Technical Service Bulletin

2017 P3 Shock Absorber
TSB1617

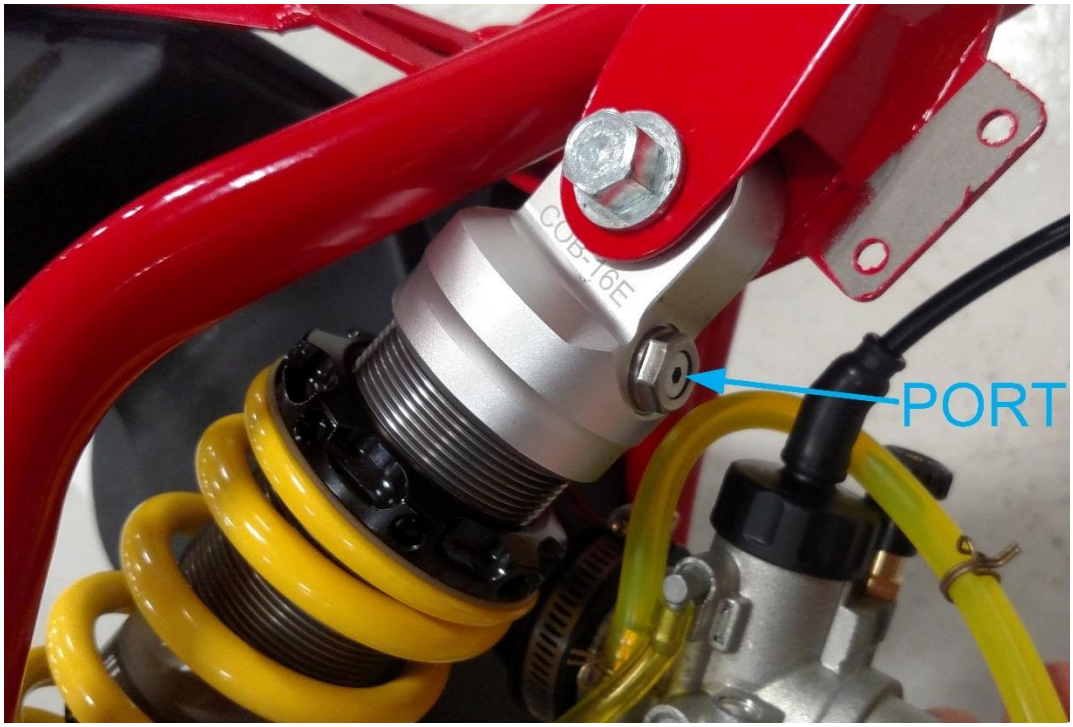
2017 CX50 P3 with VIN up through CP35017071 have shock absorbers that could contact the frame in extreme bottoming conditions.

Customers are asked to send their shock back to Cobra for a minor geometry change to the shock body cap.

Upon receiving their shock back, customers will mount the shock onto the bike in a different orientation. New mounting orientation (after the modification to the shock body cap) is show below. This new orientation has the shock body cap in the upper mount with the pressure access port visible toward the engine

CAUTION:
Do not mount your shock in this orientation without first getting the modification done to the shock body cap or damage will occur.
